Cracked Fuses on Powertrain Power Distribution Modules

54-58

**Western Star
Service Bulletin**

Fig. 1, Wrapping the PDM Harness with Electrical Tape

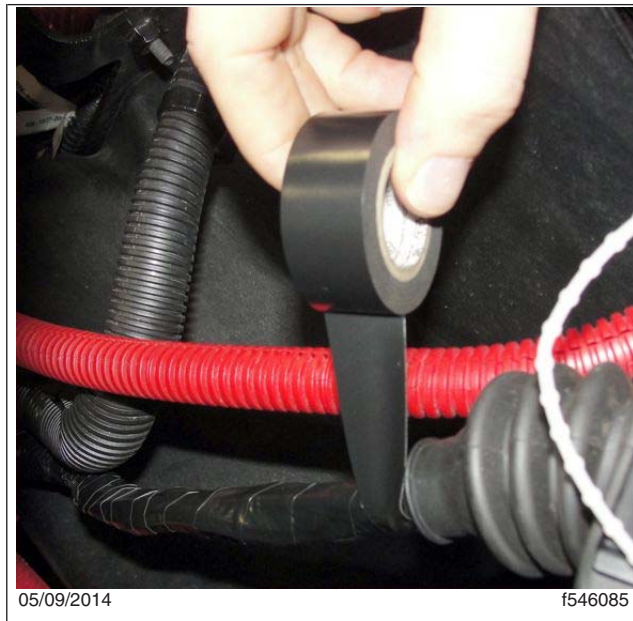
The fuses on horizontally-mounted powertrain power distribution modules (PDM) may crack due to vibration. Use the instructions in this bulletin to reduce the level of vibration on the PDM.

1. Park the vehicle, shut down the engine, and apply the brakes. Chock the tires.
2. Open the hood.
3. Remove the split loom from the PDM harness and discard.
4. Wrap a 6-inch (15-cm) length of the harness with electrical tape, starting at the base. See [Fig. 1](#).
